Product Change Notification

PCN No: 2021-04-16-01
Report Date: April 16, 2021
Subject: HTT70A-TPN Display Change
HTT70G-TPC Display Change
HTT70A-TPR Display Change
HTT70A-TPC Display Change

New 7.0" TPN display

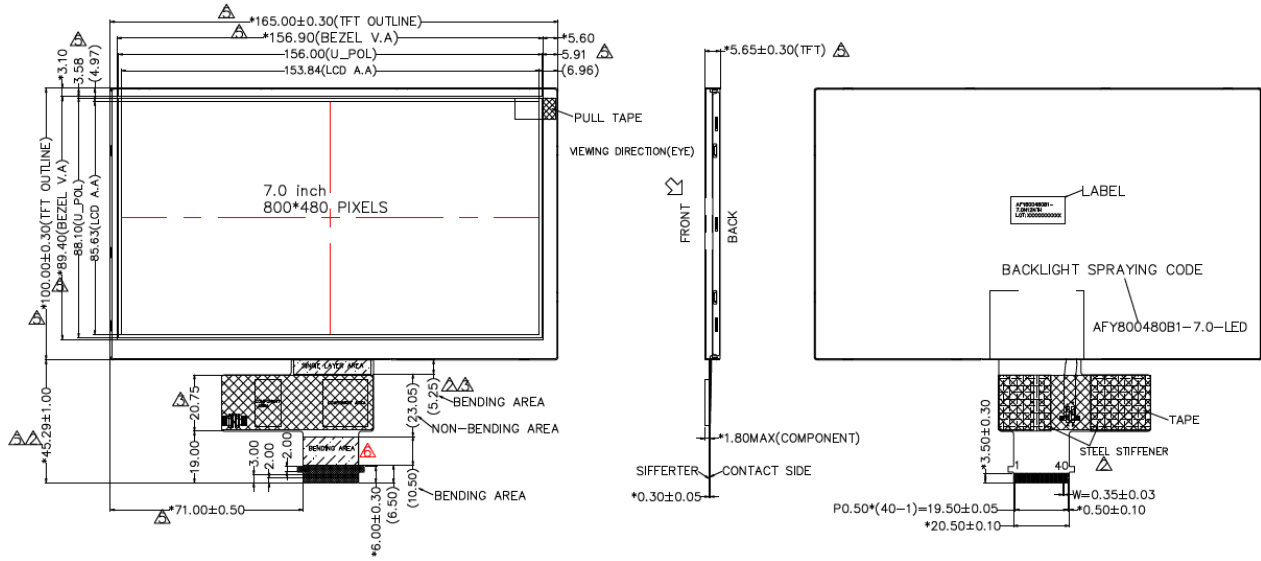
The display mechanically has become thicker with minimal module mechanical change.

Current	New
Module size (L*W*H) mm	TPN: 164.9 * 100.0 * 3.5 TPR: 164.9 * 100.0 * 4.7 TPC: 164.9 * 100.0 * 5.4 G-TPC: 179.9 * 119.0 * 5.8	TPN: 165.0 * 100.0 * 5.6 TPR: 165.0 * 100.0 * 6.9 TPC: 164.9 * 100.0 * 7.5 G-TPC: 179.9 * 119.0 * 7.9
Active area (L*W)	153.84 * 85.63	153.84 * 85.63
Pixel pitch (L*W)	0.192 * 0.178	0.192 * 0.178
